PLANNING &
COMMUNITY
DEVELOPMENT
COMMISSION

DEVELOPMENT REVIEW: LYONS VALLEY TOWNHOMES

March 10, 2020

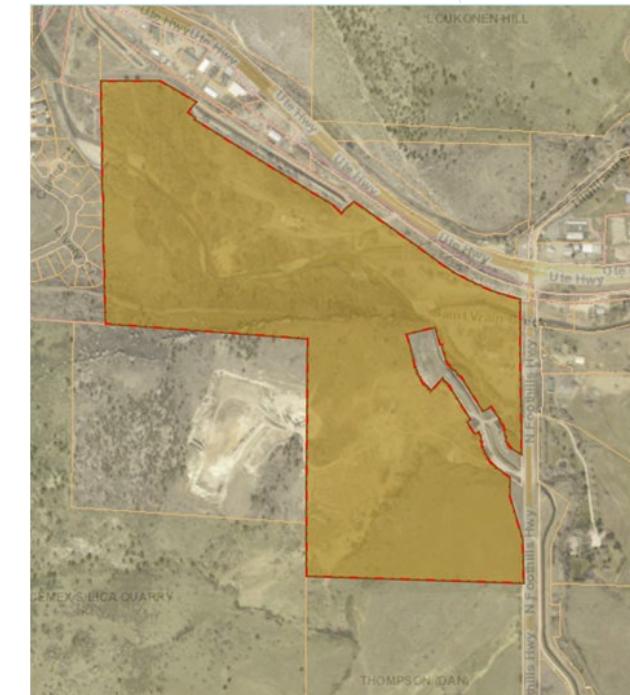
Since the development plan agreement considers infrastructure for Lyons Valley Park, Filing 8, preserve a trail and road access easement to 12993 N. Foothills Highway (see image to right).
